Addendum No. 1

RE: Contract # C204404

Cumberland County (U-4405A)

US-401 FROM OLD RAEFORD RD TO EAST OF NC-162 (BUNCE RD)

MATCHLINE SEE SHEET UC-9
-Y5- STA 23+00

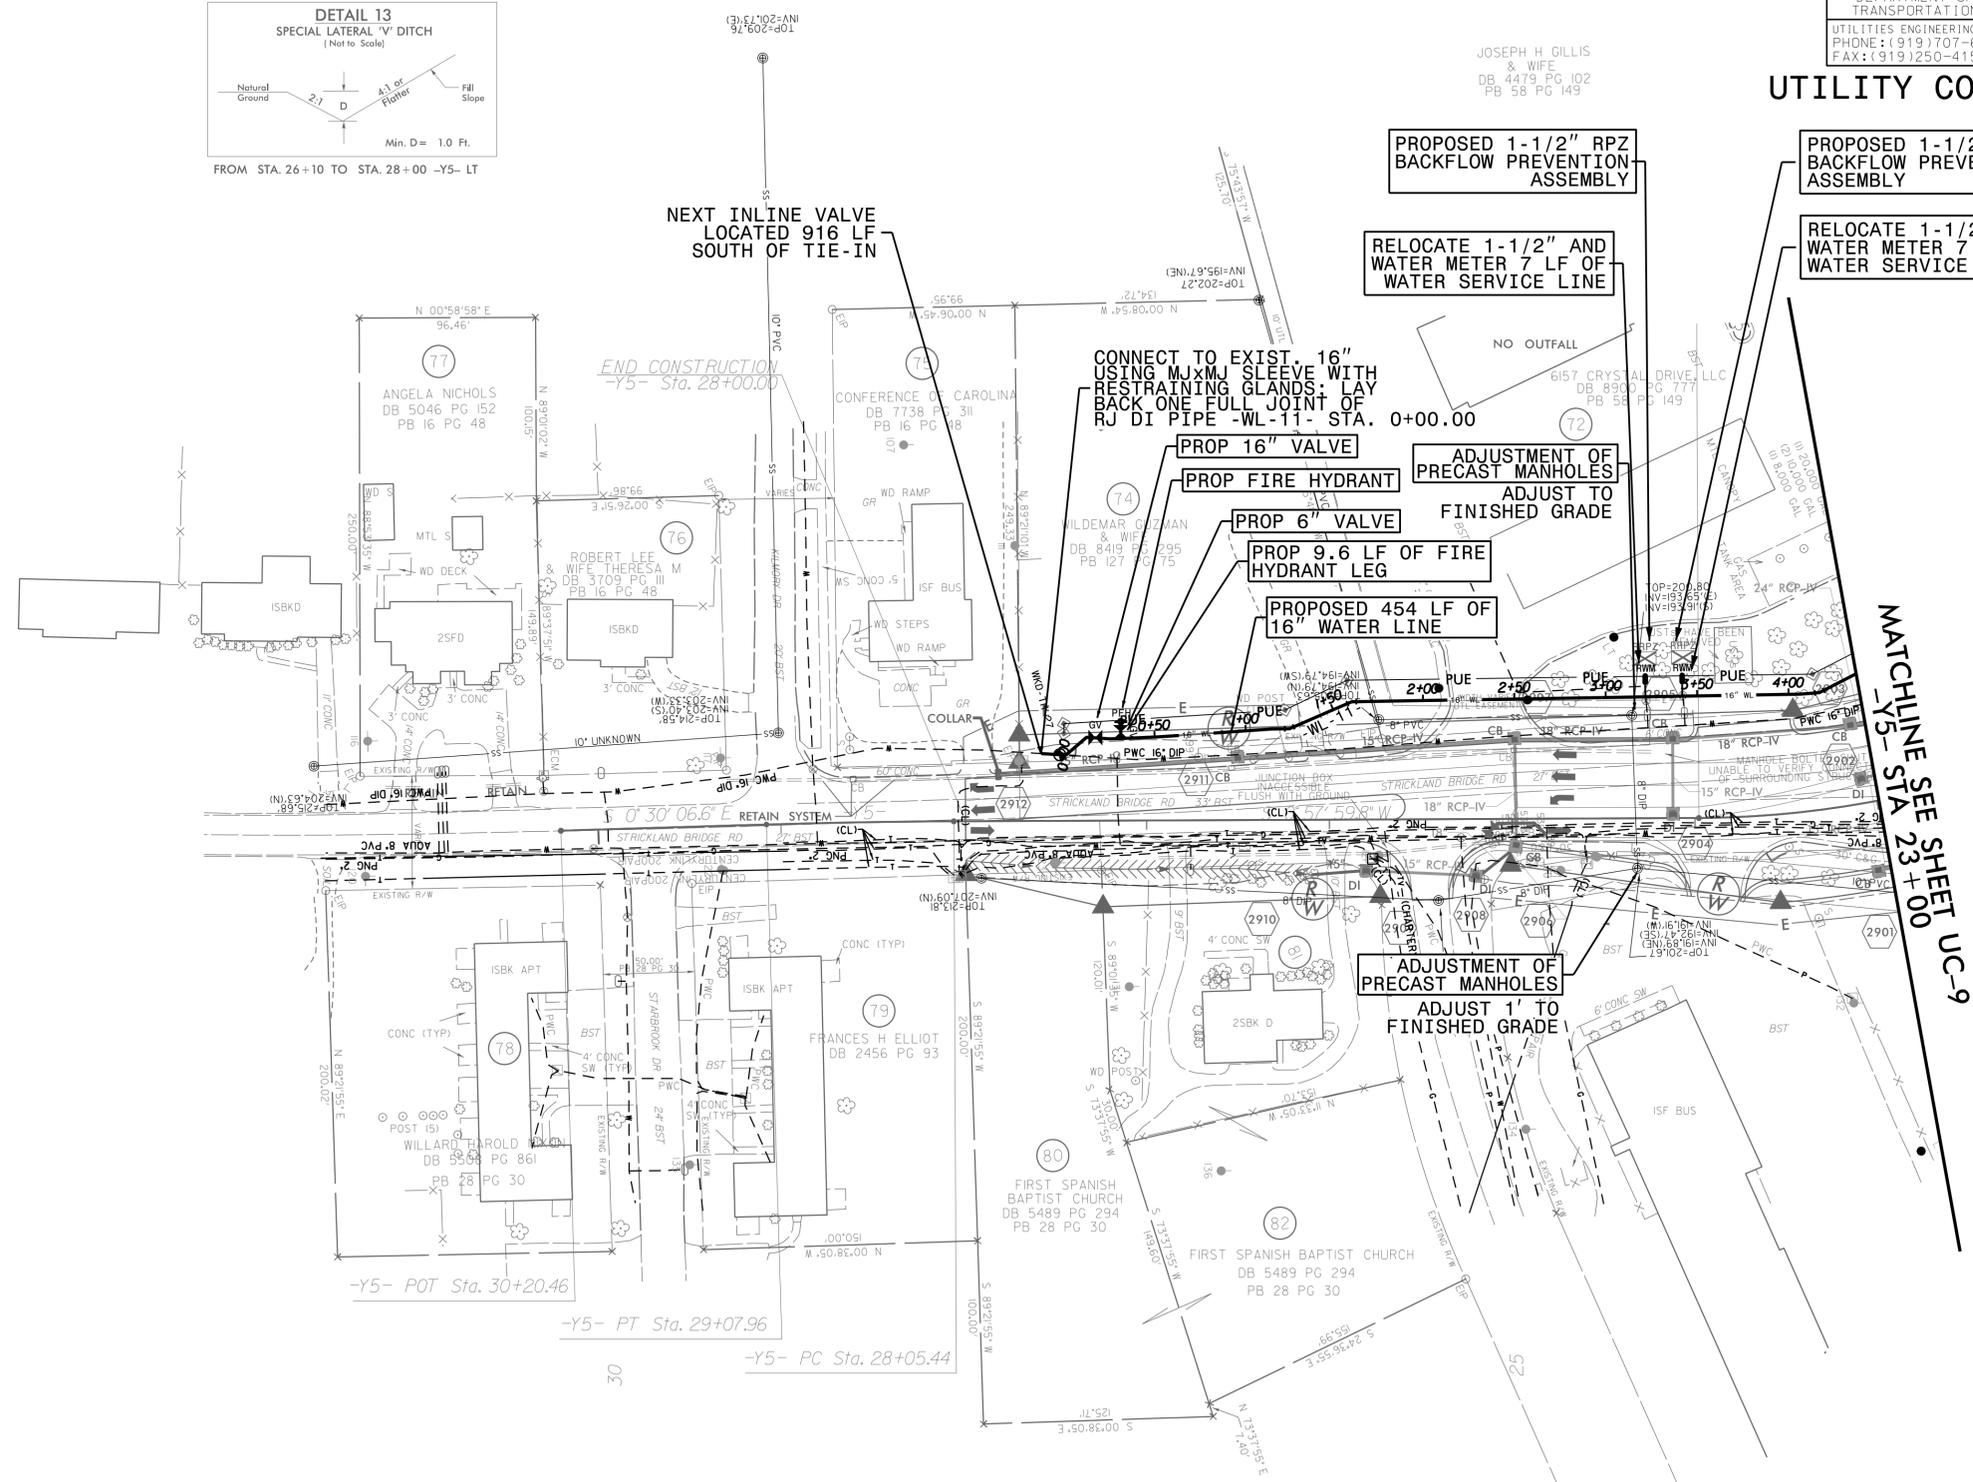
| Sheet No. | Revision |
|-----------------|---|
| UC-9B | YSTA 24+00 RT, ADDED CALLOUTS FOR RELOCATED METER RPZ AND SERVICE LINE (2 EACH) |
